MONUMENT
ACADEMY

SITE DEVELOPMENT PLAN

SITE LIGHTING
PHOTOMETRICS

Monument Academy Soccer East Campus
Colorado Springs,CO

1 SITE LIGHTING PLAN - OVERALL SITE
1" = 60'-0"

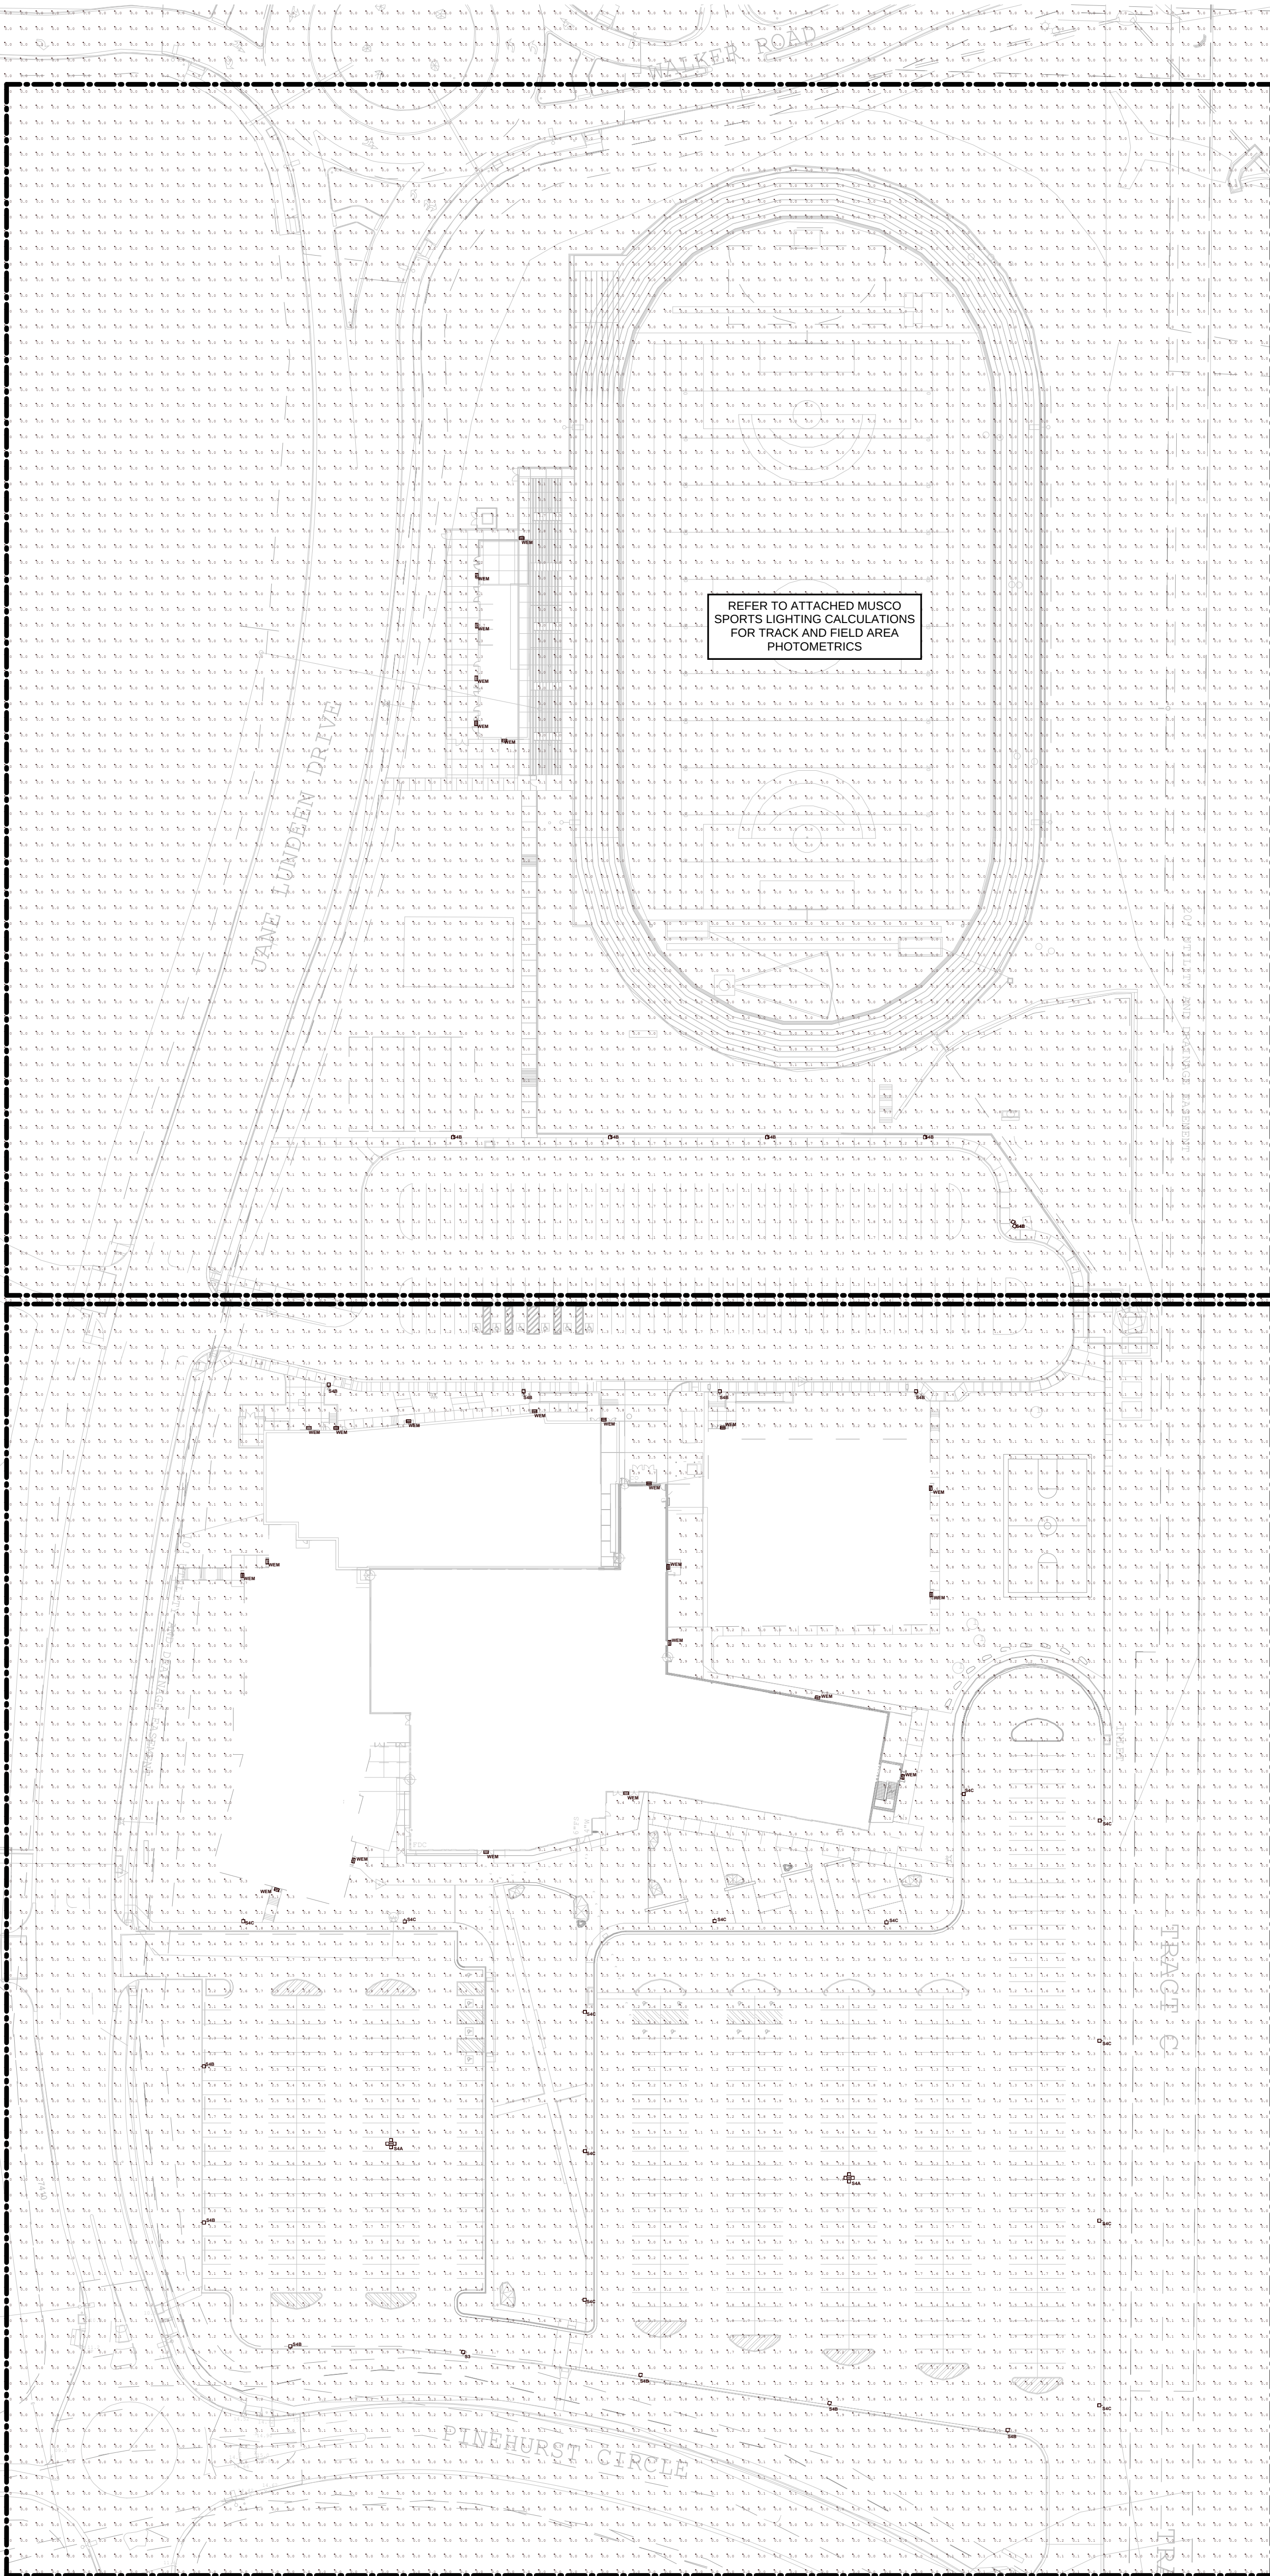
- (2) Height. No freestanding light fixtures shall be mounted higher than 15 feet, except parking lot light fixtures which shall be mounted no higher than 20 feet unless an alternative lighting proposal is approved in accordance with this Code.

Please confirm that lighting will meet the following standards:

- (a) **Concealed or Shielded.** Light fixtures shall be arranged and positioned such that the light sources are concealed and fully shielded so that no direct light or reflection creates a nuisance or hazard to any adjacent ownership or right-of-way and that up-light, spill-light, glare, and unnecessary diffusion are minimized. Light fixtures, except as otherwise permitted herein, are required to be full cutoff as defined by the Illuminating Engineers Society of North America (IESNA) The cut-off angle of an exterior light source shall not exceed 90 degrees. Full cut-off fixtures may not be tilted or aimed in a manner that results in light distribution above the horizontal plane. The use of semi-cutoff or cutoff (as opposed to full cutoff) fixtures shall be permitted to illuminate areas other than parking lots provided the pole or mounting point is no more than 10' in height and the maximum lumen output does not exceed 1800 lumens per lamp.

- (b) **Non-Security Lighting During Non-Operating Hours.** Exterior lighting, including but not limited to floodlights used to light a building façade, shall be reduced, activated by motion sensor devices, or turned off during the principal use's non-operating hours. Lighting necessary for security shall not be subject to this provision.

PRELIMINARY FOUNDATION AND POLE ASSEMBLY DRAWING

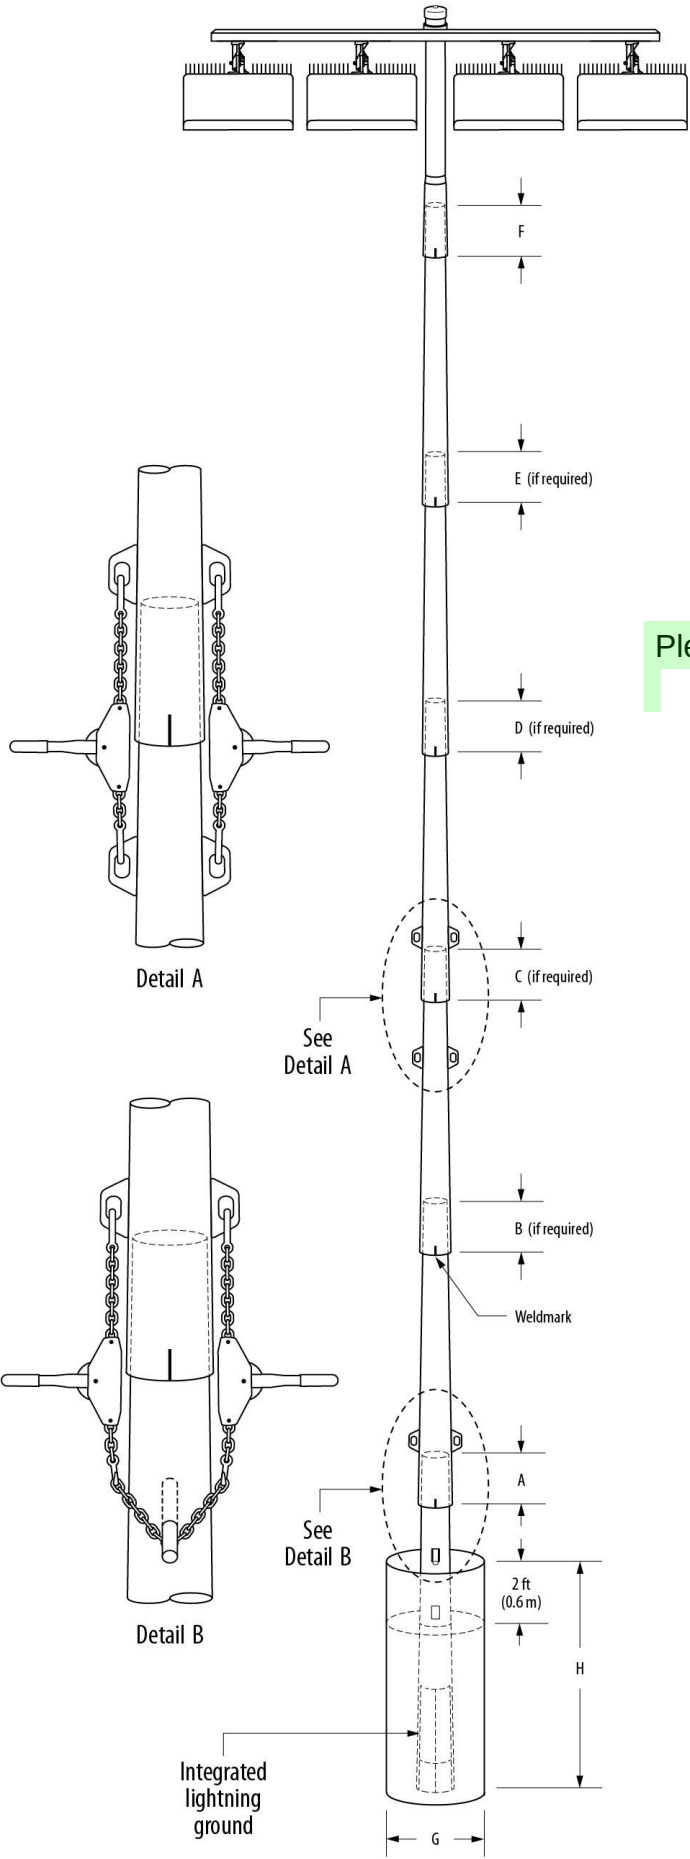
Please confirm that recreation area lighting will meet the following standards:

- (b) **Cut-Off Angle.** The cut-off angle from a lighting source that illuminates an outdoor recreational use may exceed 90 degrees provided the light source is shielded to prevent light and glare from spilling to adjacent residential properties.
- (c) **Hours of Use.** Exterior lighting for an outdoor recreational use shall be extinguished no later than 10:00 p.m. or immediately after the conclusion of the final event of the day, whichever is later.
